Addendum No: 3

Project #N662030002 UHN Prince George UHN Cardiac Diagnostic Phase 2 (Burn)

Issued for Tender – Addendum #3

2.1 Drawing M101: Demolish existing exhaust air grill and duct branch and cap off between GL. K/7 and K1/7 as shown clouded in below snip.

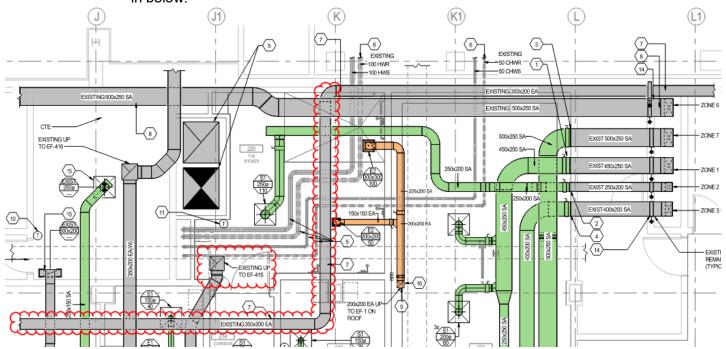
2.2 Existing 300x200 E/A duct routing is updated as shown clouded. The location of existing E/A duct up to existing exhaust fan on the roof is updated as shown clouded in below.
